SUBJECT: Forwards info requested in NRC 960328 RAI re util 951116  
response to NRC Bulletin 95-002, "Unexpected Clogging of RHR  
Pump Strainer While Operating in Suppression Pool Cooling  
Mode."

**Subject:** *NRC Bulletin 95-02, "Unexpected Clogging of a Residual Heat Removal (RHR) Pump Strainer While Operating in Suppression Pool Cooling Mode"*

#### ***REQUEST FOR ADDITIONAL INFORMATION***

CORE & CONTAINMENT SPRAY PLAN

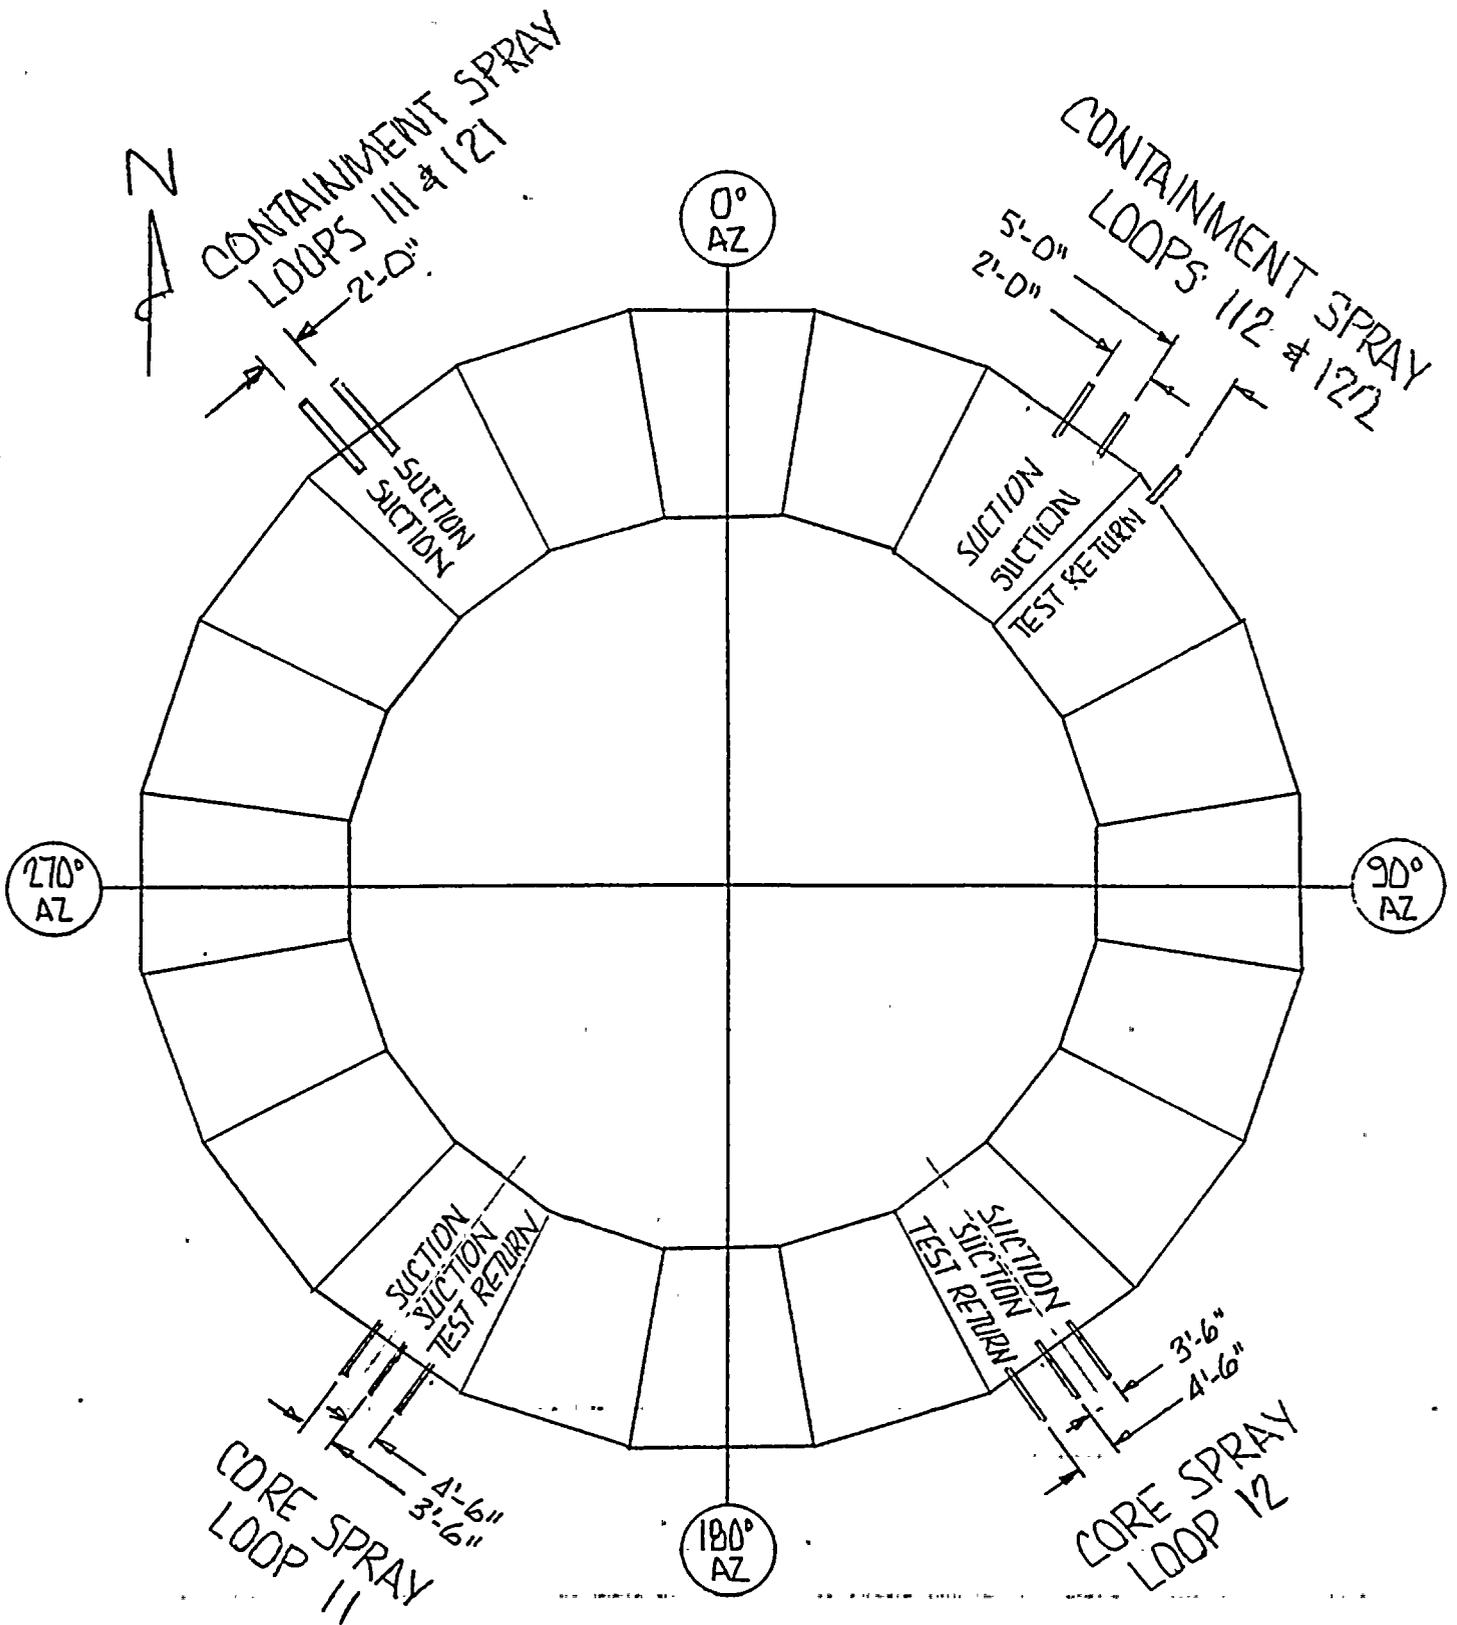
low-pressure coolant injection to the suppression pool oriented (e.g., do they discharge directly towards the center of the torus, or do they direct flow axially around the torus)?

Concerning the orientation of the return lines, they enter the torus approximately 60° apart, perpendicular to the torus (i.e., directing flow towards the center of the torus). Accordingly, they do not direct flow in a circular motion around the torus. The configuration of the torus suction and return lines for the Core Spray and Containment Spray System are shown in the attached figure.
